**Information Request : D/22-2019**

**9A Reynolds St, LAKES CREEK**

**Lot 49 / RP 603376**

**INFORMATION REQUEST – DEVELOPMENT APPLICATION D/22-2019 FOR A MATERIAL CHANGE OF USE FOR A DWELLING HOUSE AND SECONDARY DWELLING – SITUATED AT 9A REYNOLDS STREET, LAKES CREEK – DESCRIBED AS LOT 49 ON RP603376, PARISH OF ARCHER**

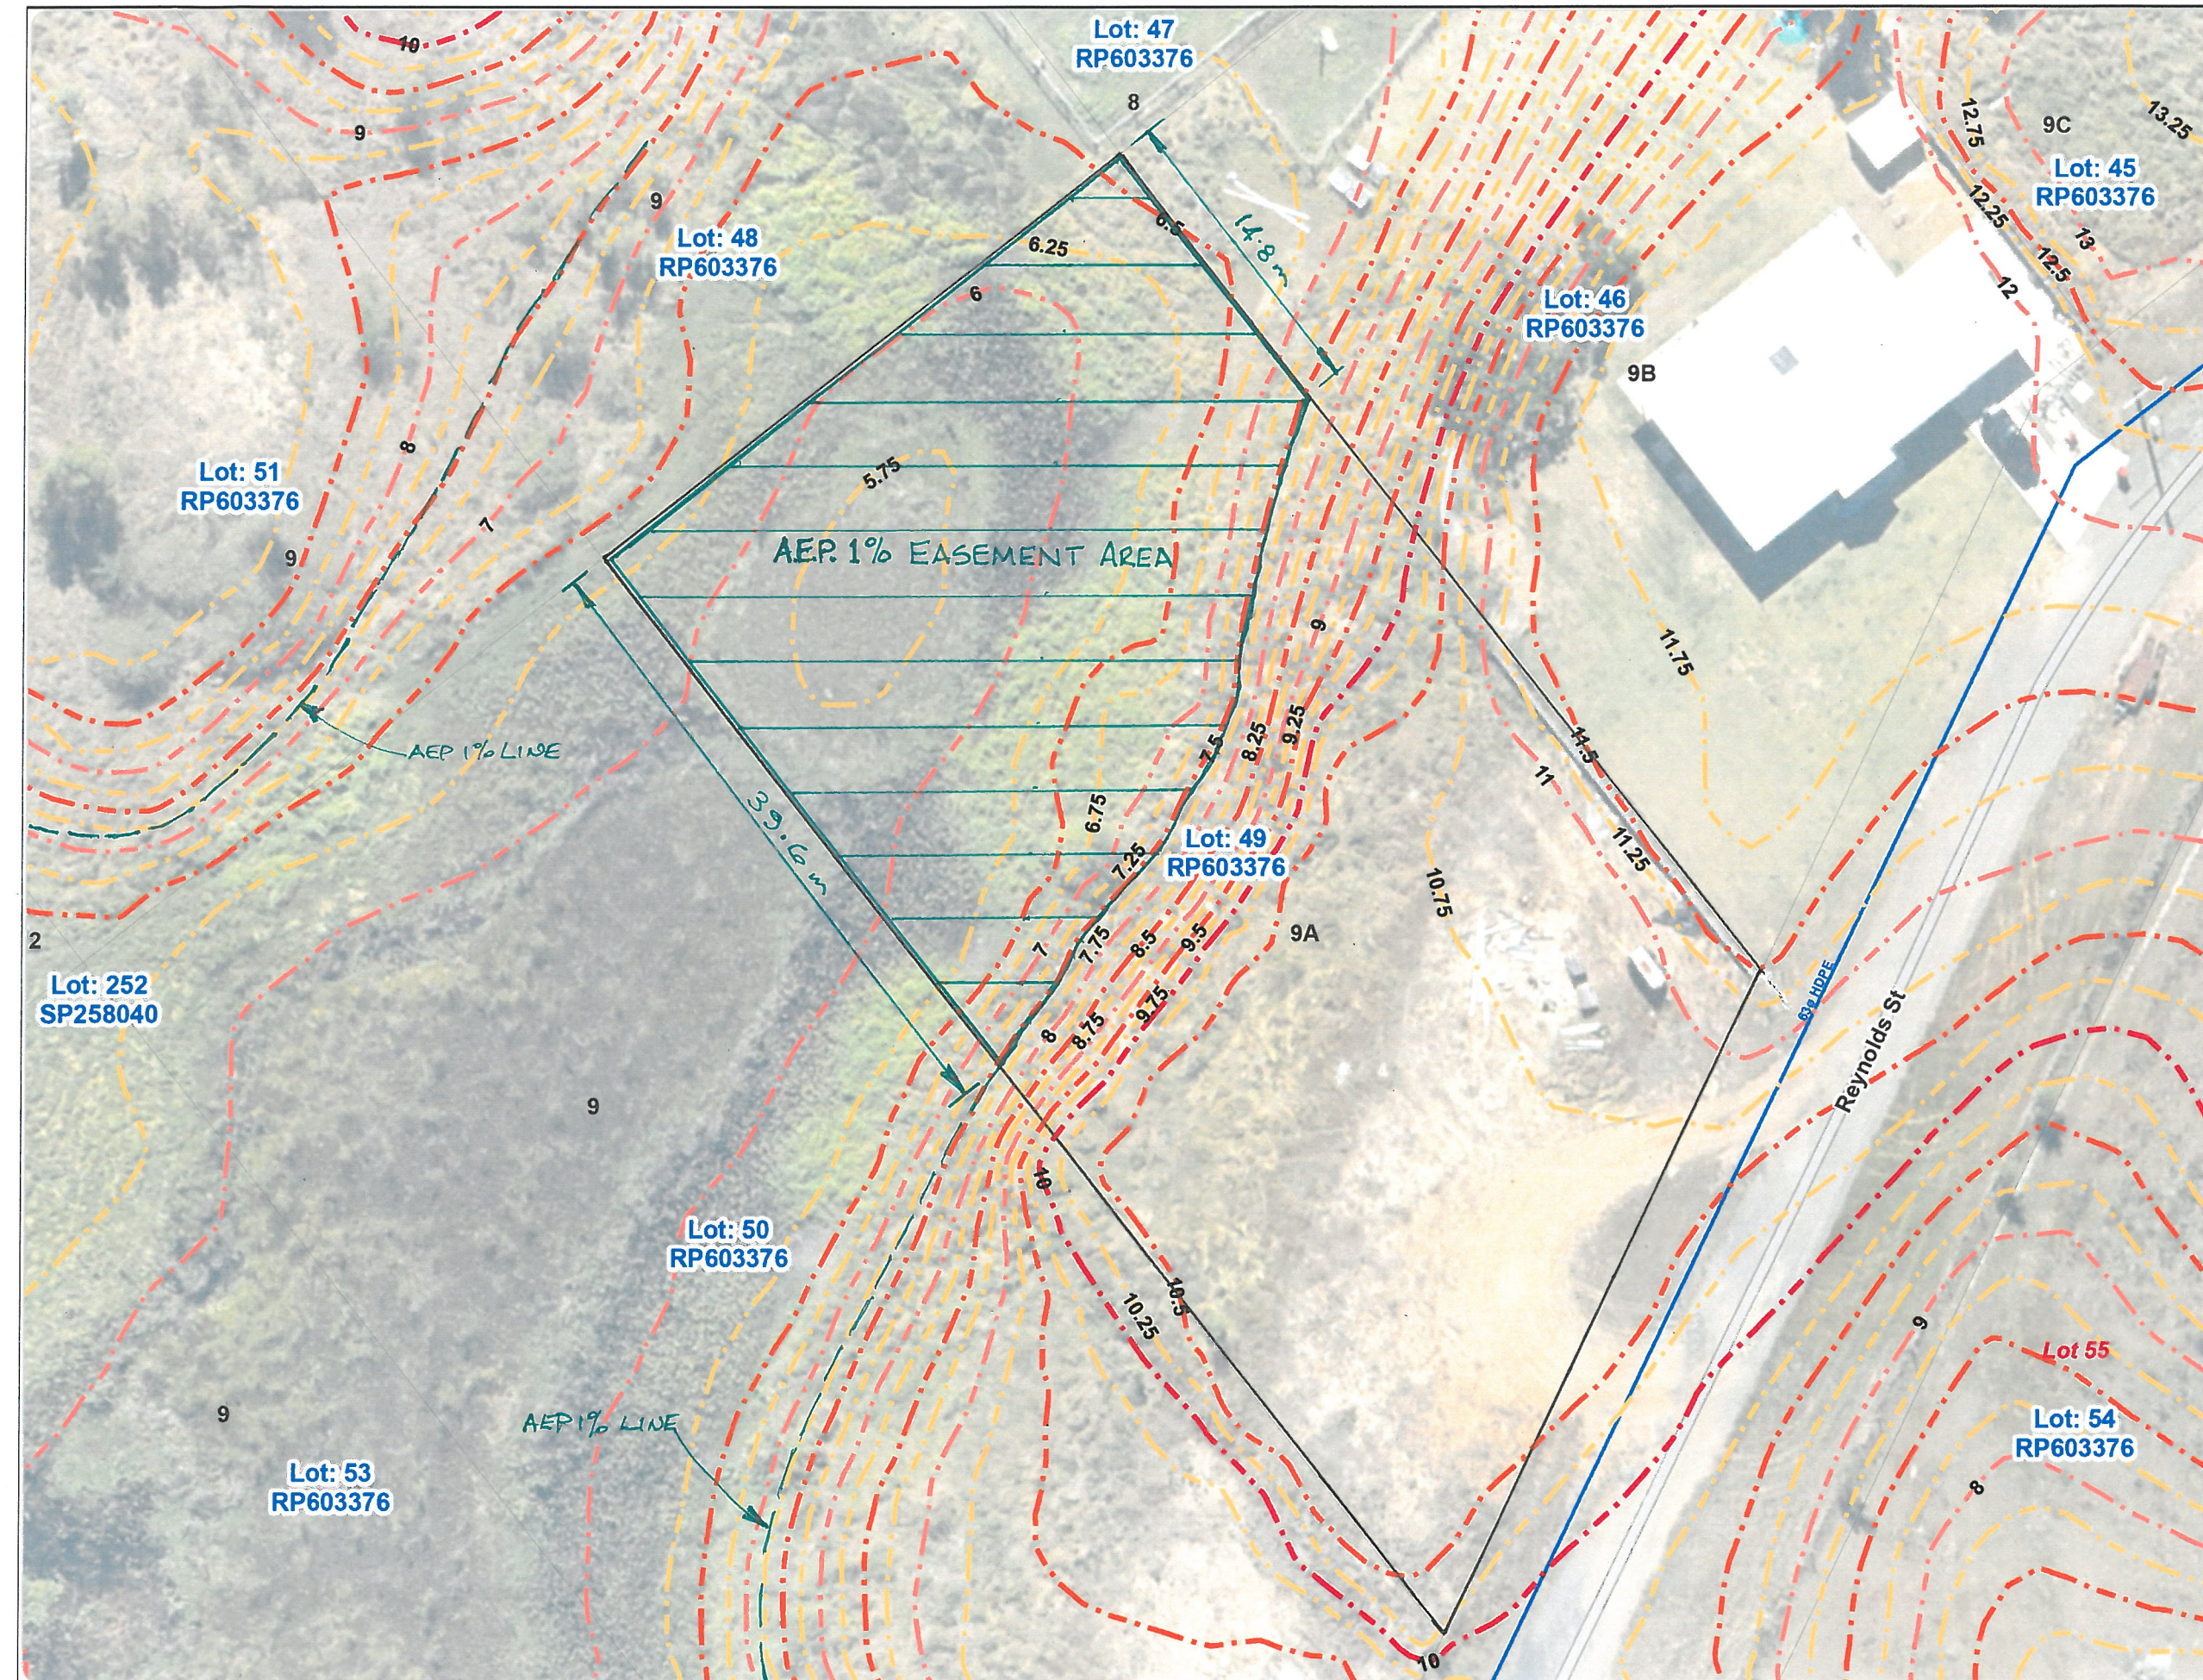
- 1. Catchment Area** – The watershed for the gully traversing this allotment is identified on the attached plan. The two road inverts at the intersection of Montgomerie & Totteridge Streets direct the water north of Montgomerie St across these roads and into the head of the Reynolds St catchment.
- 2. Peak Discharge** – This catchment lies on the outskirts of the suburban area and its allotment sizes are large. Infill to a more dense housing layout is not anticipated in this area for many years future. Allowing for some infill on several existing vacant allotments the fraction impervious from the aerial imaging is 0.079.

- 3. Inundated Area** – A conservative calculation of the area likely to be covered in an AEP 1% Exceedence flow in this catchment is given in the appended plans and for reasons given later below should be given at the 7.5m contour level. At this level the areas towards the rear of this allotment are all covered while the areas for buildings etc towards the Reynolds Street frontage are approx 3metres above the inundation level.
- 4. Calculations & details** – The full calculations for the catchment discharge and flow levels are given on the appended plan showing the Catchment Area.

GULLY WIDTH @ 7.6m  $\approx 51.5\text{ m}$ .  
BACKWATER SLOPE  $1\text{ in } 270$  (ASSUMED).

$$= \frac{(51.5 \times 0.134) \times \left( \frac{51.5 \times 0.134}{51.768} \right)^{2/3} \times (0.004)^{1/2}}{0.045 \text{ (OPEN GULLY FLOW)}}$$

$$= \frac{6.901 \times 0.241 \times 0.061}{0.045}$$

$$= 2.435\text{ cumecs.}$$

Lot 49 on RP603376  
9A Reynolds Street, Lakes Creek  
Services and Contours  
Date: 04/04/2019

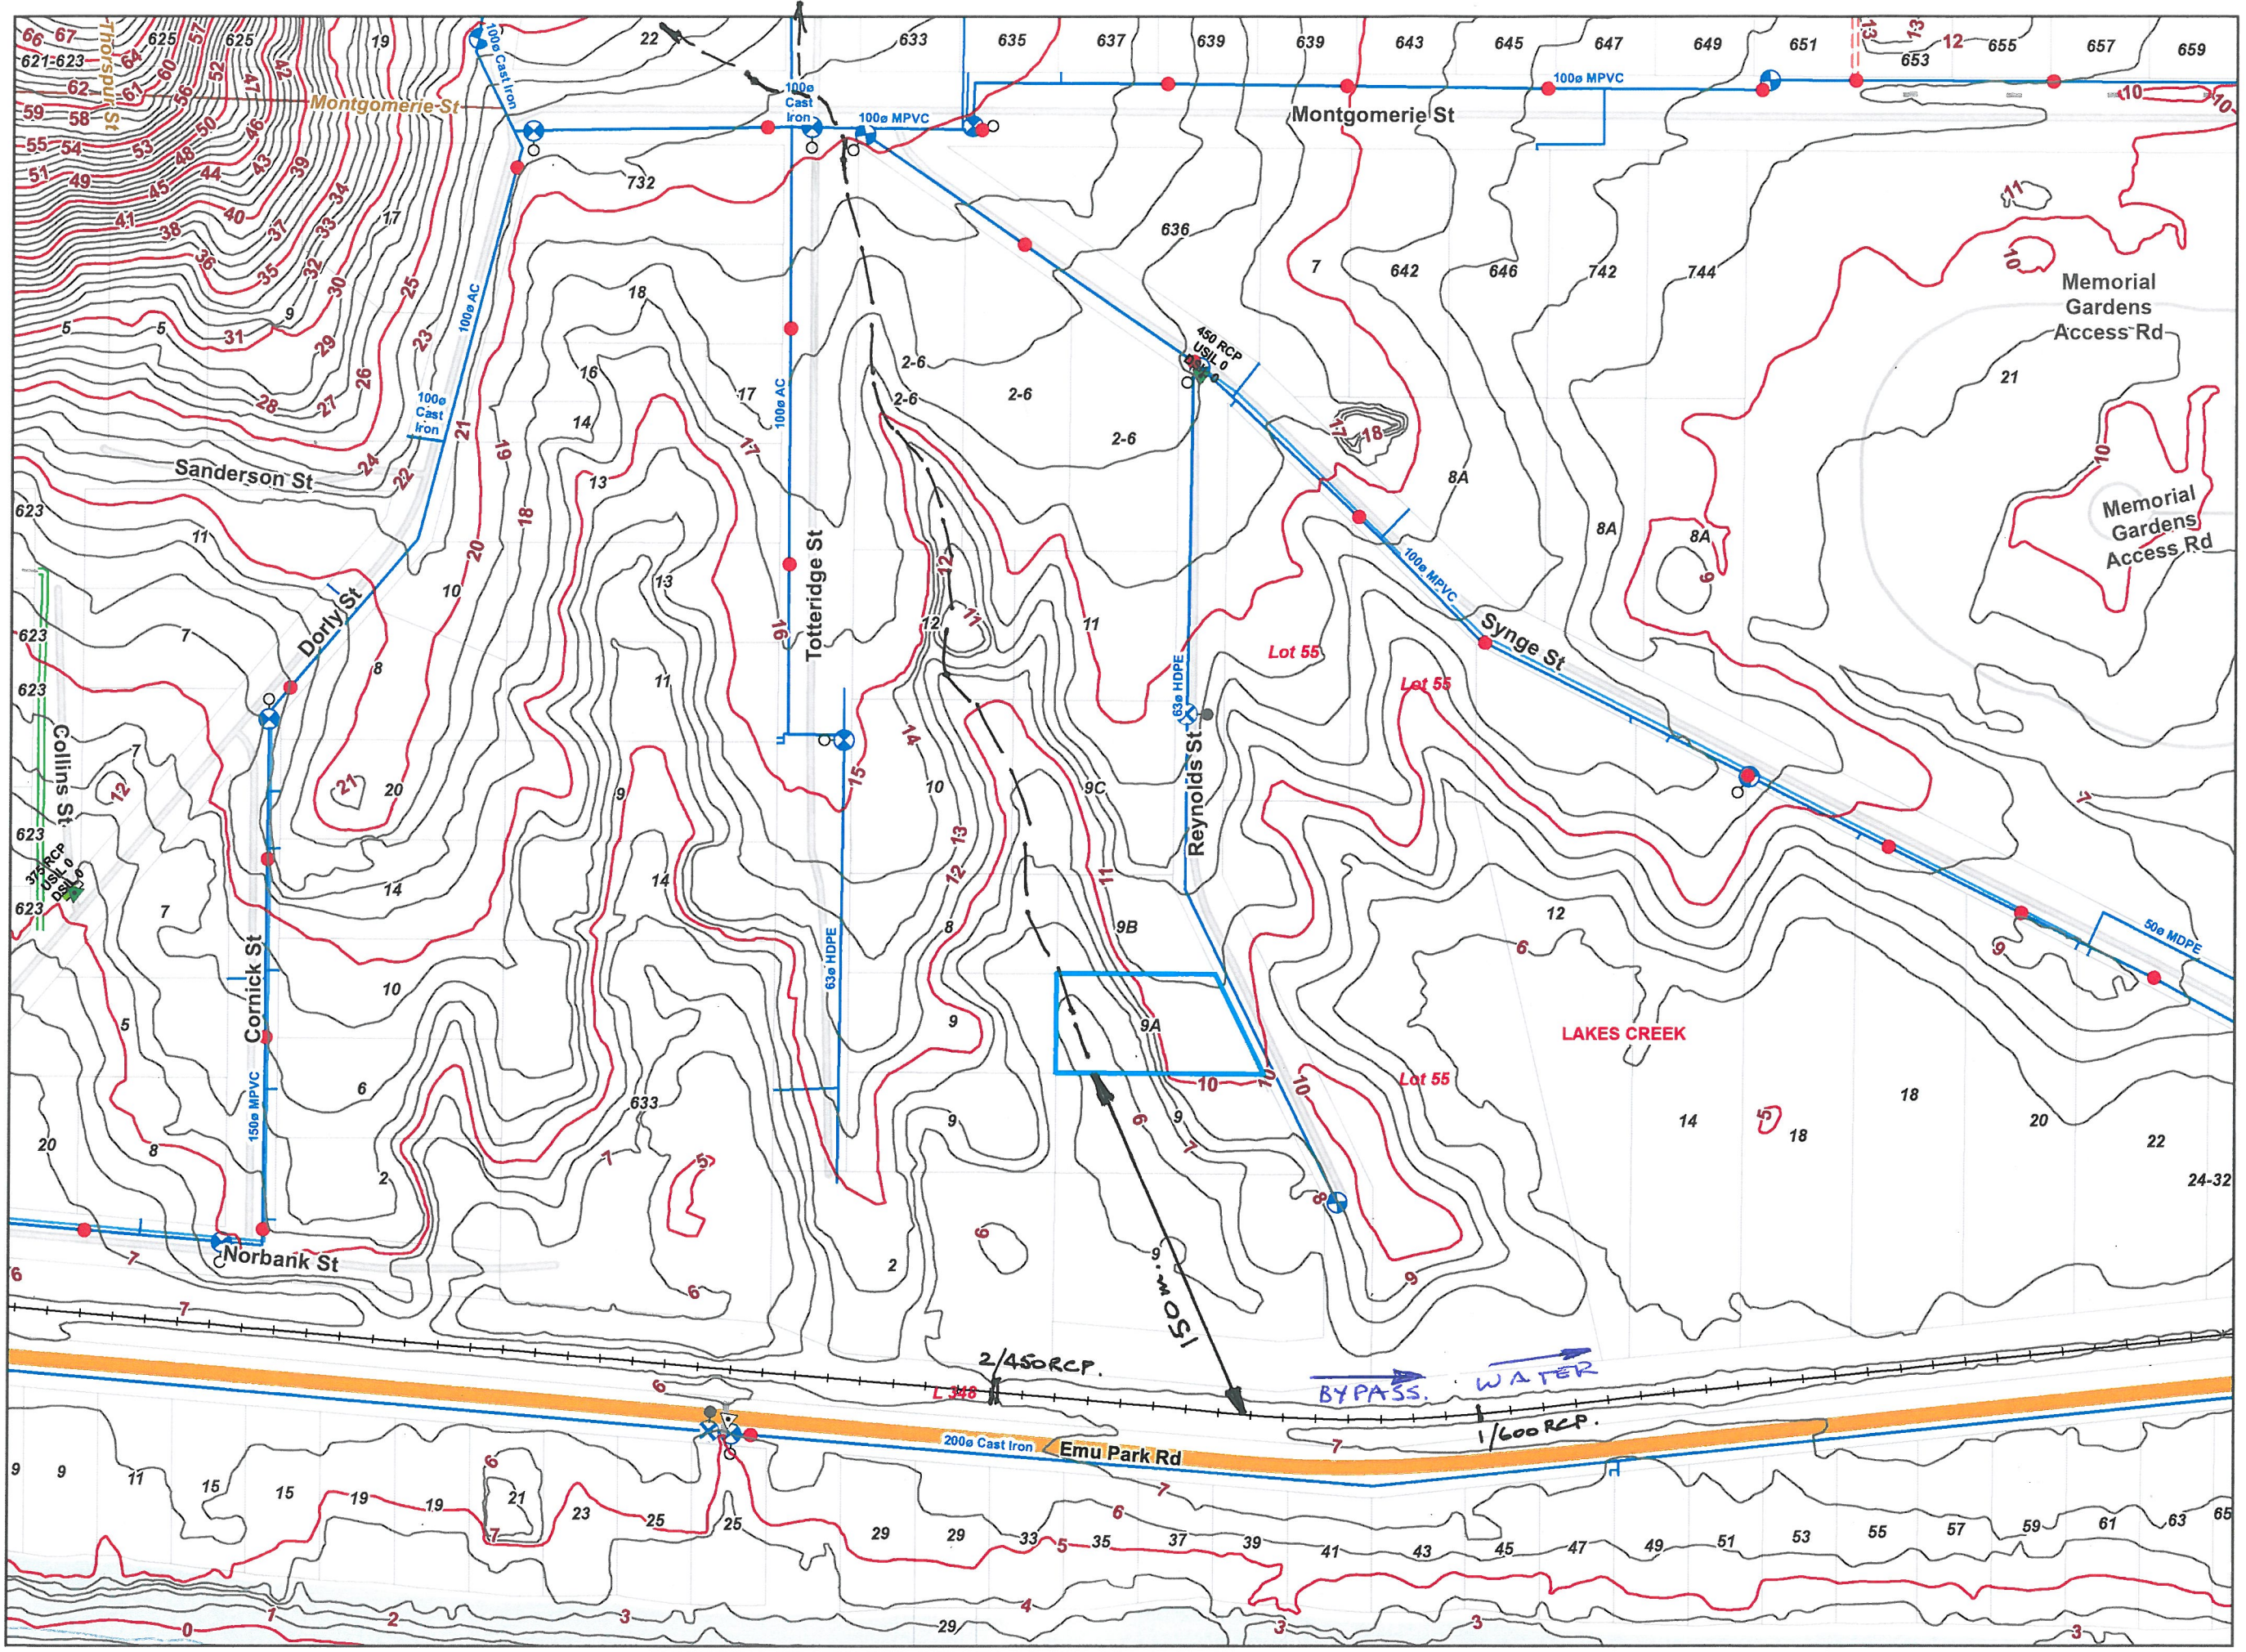
Note: A Desktop assessment indicates that the existing highway and railway embankment in the south west acts as a hydraulic control for a number of sub-catchments. Stormwater detention / retention occurs towards the north east of the hydraulic control line together with overflow between the sub-catchments. An assessment of the water level behind the hydraulic control needs to be undertaken for a one percent

(1%) Annual Exceedance Probability defined flood event. Some commentary on the hydraulic control should be included.

From the plans it is noted that the rail formation is at approx 7.0 AHD. The railway culverts along this section of track are small pipes which do not pass the runoff from the catchments above them but rather the rail formation diverts these catchments to the east to the larger gully crossing near Hartington St which is a rail bridge. The invert of the gully is approx 2.5m below 7.0m.

The level of inundation in the gully at No 9A Reynolds St of 7.5m AHD is therefore quite conservative and in any event well below the useable building platform on this allotment. The proposed development on the building platform represents no risk from flooding.
